Work Order ID 78577

Item Name: Crosstube Fwd

DART AEROSPACE LTD		Work Order:	78577
Description: Crosstube High Fwd (205/212/412)		Part Number:	D212-664-101
Inspection Dwg: D212-664-141 Rev: D		Page 1 of 1

DRAWING NO. D212-664-141	TITLE XTUBE ASSY (205/212/412 HI FWD)	REV. D	DART AEROSPACE LTD ENGINEERING ORDER		D.E.O. NO. D212-664-141-D-1	SHEET NO. SHEET 1 OF 2	SCALE NTS
DRAWN	CHECKED	MFG. APPR.	APPROVED	DE APPR.			
DATE 11.04.07	DATE 11.04.11	DATE 11.04.12	DATE 11/04/12	DATE 11.04.12

D212-664-141/-141B
ASSEMBLY DETAIL

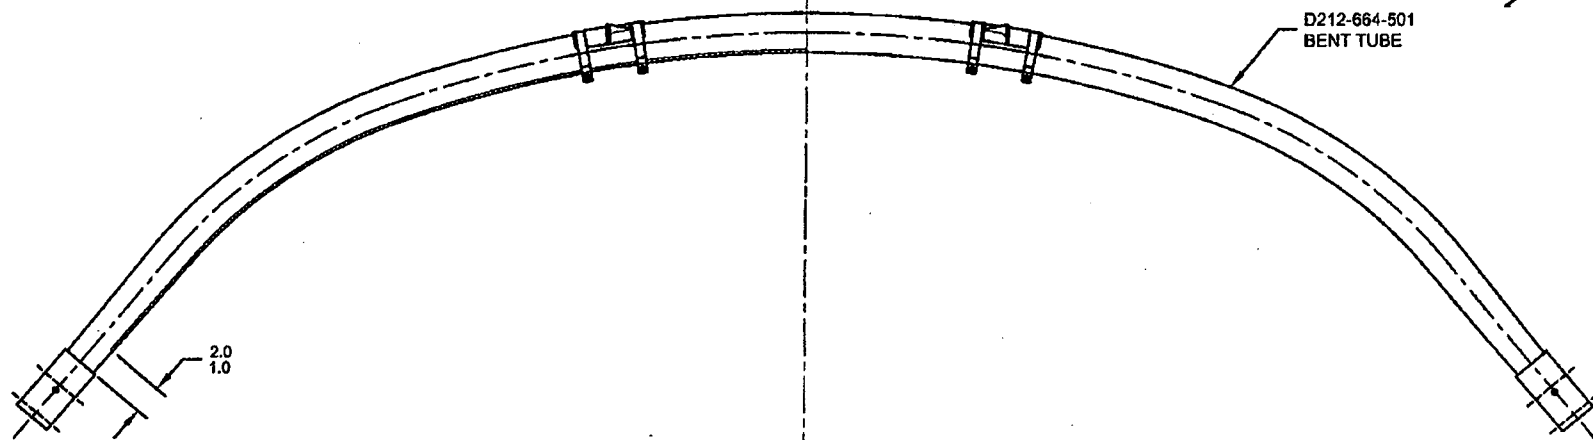
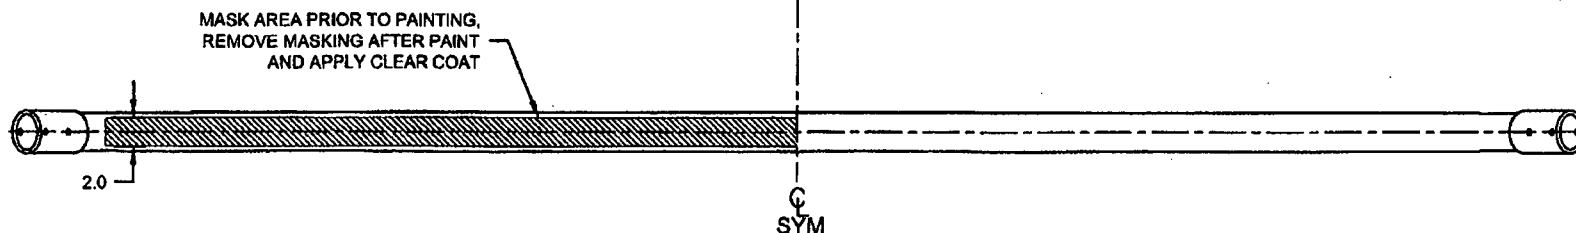
PURPOSE:

ADD AN INSPECTION WINDOW TO UNDERSIDE OF CROSSTUBE.

NOTES 2 OF SHEET 1 IS AMENDED AS FOLLOWS:

IS:

WAS:

- 2) FINISH: CHEMICAL CONVERSION COAT PER DART QSI 005 4.1
PRIME INSIDE AND OUTSIDE PER DART QSI 005 4.2
MASK UNDERSIDE OF CROSSTUBE AS SHOWN (HATCHED AREA) AND
PAINT OUTSIDE PER DART QSI 005 4.2
REMOVE MASKING AND APPLY CLEAR COAT
